Startup Change Proposal

September 2, 2005
Brett McClellan

Transition Counter Change

Transition Counter Change

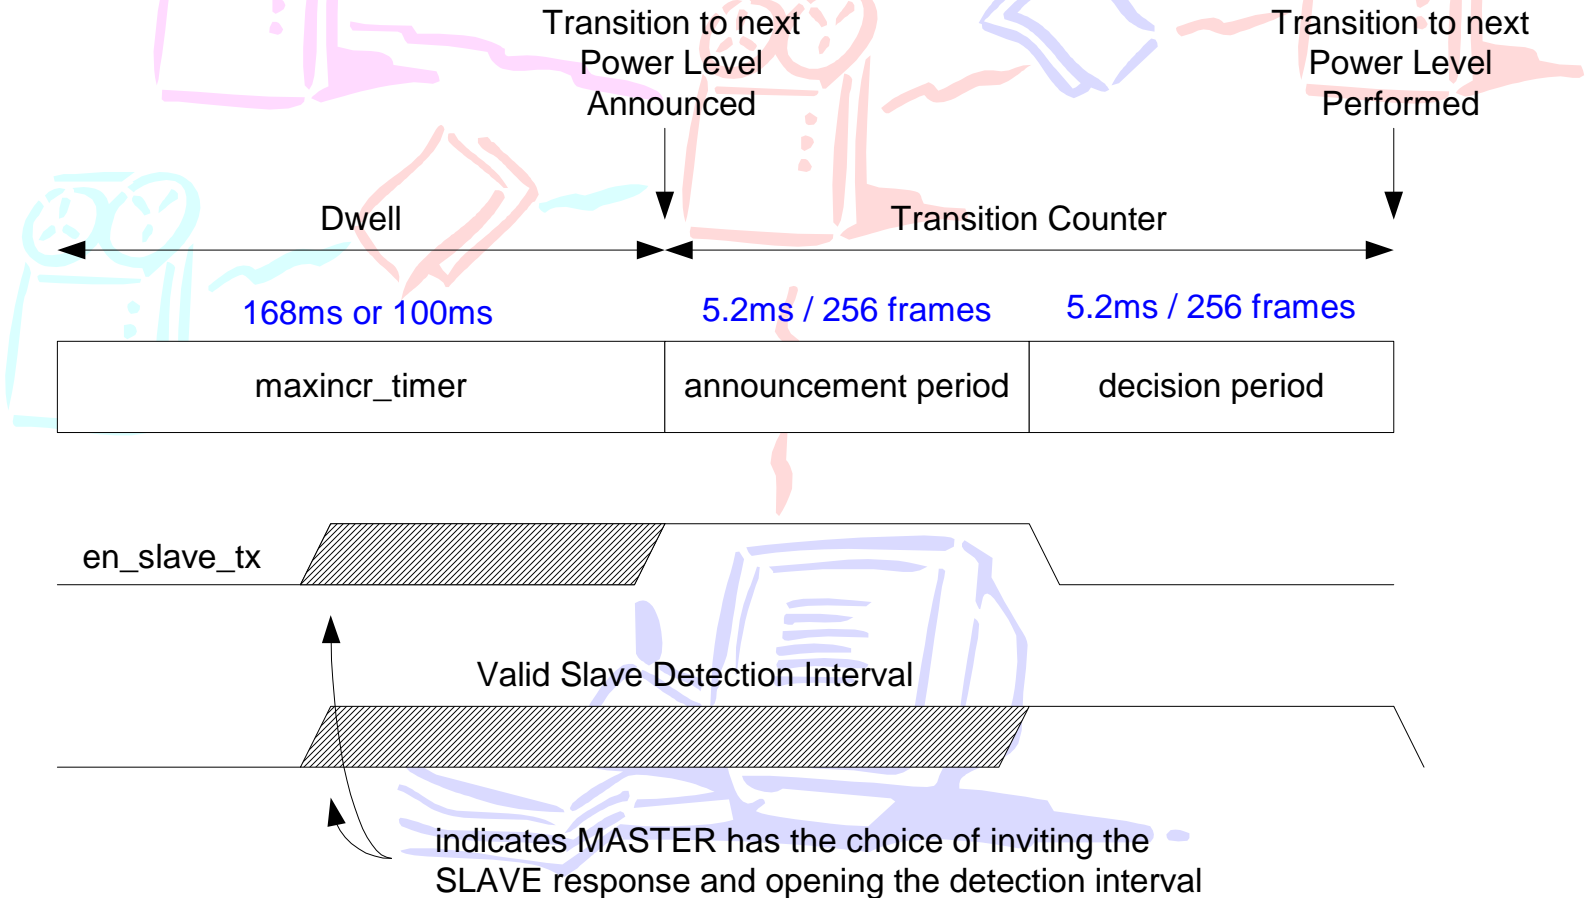
- Eliminate the condition of $\text{transition_count} \geq 2^6$
 - Allows detection of SLAVE training pattern up to transition point
- Select a fixed start value for Transition Counter
 - Reduce variables in startup
 - Propose 2^9 (~10ms)

- Text Changes: pg 117 & pg 124

If the MASTER does not detect the SLAVE **while transition_count $\geq 2^6$** , when the transition_counter expires, the MASTER increments to transmit setting master_init_step=2, which corresponds to the medium transmit power level and THP settings, PBO=5 (corresponding to a power backoff of 10dB) and THP=THPByp or THP=THPMed, the maxincr_timer is started again and en_slave_tx and PBO/THP_increase are set to zero.

PHY Control Change

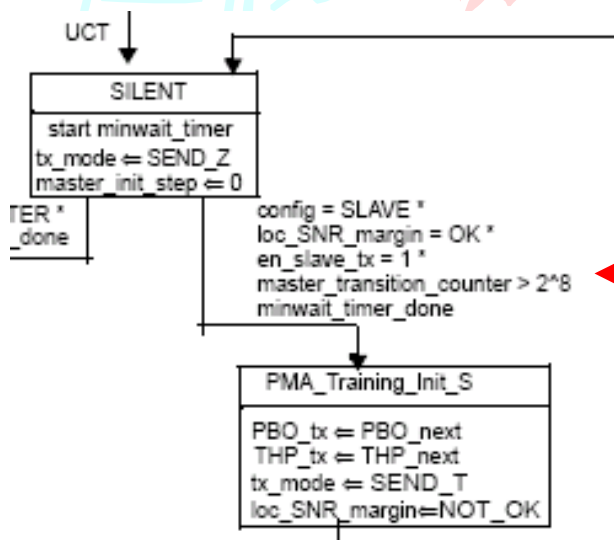
- Transition from SILENT to PMA_Training_Init_S
 - missing *
 - $master_transition_counter > 2^8$
 - redundant for first two PBO settings since en_slave_tx is set to 0 by the master when $transition_count = 2^8$
 - prevents transition to PMA_Training_Init_S for final PBO setting

Change to:

config = SLAVE * loc_SNR_margin = OK * en_slave_tx = 1 * minwait_timer_done
